## Mid-Pike Plaza Phase 2 Sewer Extension (Montrose Parkway) FCP Amendment, MR2001806

### Description

- Amendment to Final Forest Conservation Plan MR2001806 (Montrose Parkway) for construction of the Mid-Pike Plaza (Pike & Rose) sewer extension to serve Phase 2 of the Pike & Rose development, Site Plan No. 820130120;
- Right-of-way of Montrose Parkway and E. Jefferson Street between Executive Boulevard and Tilden Woods Stream Valley Park;
- Area of disturbance: 0.43 acres;
- 1992 *North Bethesda/Garrett Park Master Plan*;
- Applicant: Federal Realty Investment Trust;
- Filing date: May 6, 2014.

### Area of clearing for Phase 1 Sewer Extension

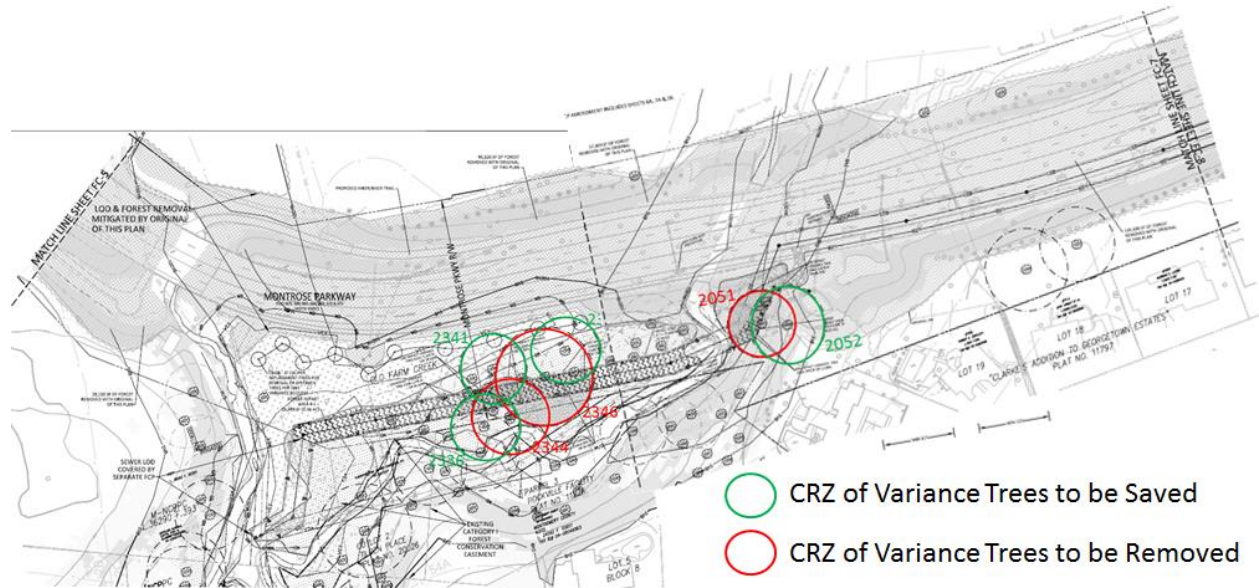
**Additional Restoration Requirement** – Phase 1 of the Pike & Rose Site Plan required a sewer extension beginning at the development and running west along Executive Boulevard approximately to the point where Executive Boulevard turns north and becomes E. Jefferson Street. From Executive Boulevard, the Phase 1 sewer extension turned south, crossed a private parking lot, and entered the Old Farm Branch stream valley to connect to an existing sewer line. The Phase 1 sewer extension will no longer be needed once the Phase 2 sewer extension is completed. At that point, the Phase 1 sewer extension will be closed off and abandoned at Executive Boulevard. This will leave the area cleared for the Phase 1 sewer extension in the Old Farm Branch stream valley unforested and open to colonization by invasive plant species. Staff recommends reforestation of this area to restore the stream buffer to a forested condition and to impede alien plant invasions. WSSC does not permit reforestation of their easement areas, so restoration plantings can only occur outside of the existing WSSC sewer easement.

Staff believes the requirement for additional restoration of the Phase 1 sewer construction area in the stream valley is justified because construction of the Phase 1 sewer was done at the option of the Applicant in order to proceed more quickly with construction of the first phase of their Site Plan. The Applicant had the option of constructing only the portion of the sewer extension along Executive Boulevard, E. Jefferson Street, and Montrose Road being considered by the Planning Board in the Phase 2 plan review. Had the Applicant opted to wait and construct only the Phase 2 sewer extension, clearing of the Old Farm Branch tributary stream valley for the Phase 1 sewer extension would have been unnecessary.

Afforestation/reforestation credit cannot be given for restoration of this area unless the forest is permanently protected within a Category I Forest Conservation Easement or given similar permanent protection. This area, cleared for the Phase 1 sewer extension in the Old Farm Branch stream valley, is largely on private property not owned by the Applicant, so the Applicant does not have authority to establish a Forest Conservation Easement on this property.

The Forest Conservation Plan for the Phase 1 sewer extension (SC2013002), approved on October 4, 2012, records that 0.30 acres of forest was cleared for construction of the sewer line. Staff recommends that portions of this area lying outside of the existing WSSC sewer easement be reforested by December 31, 2015.
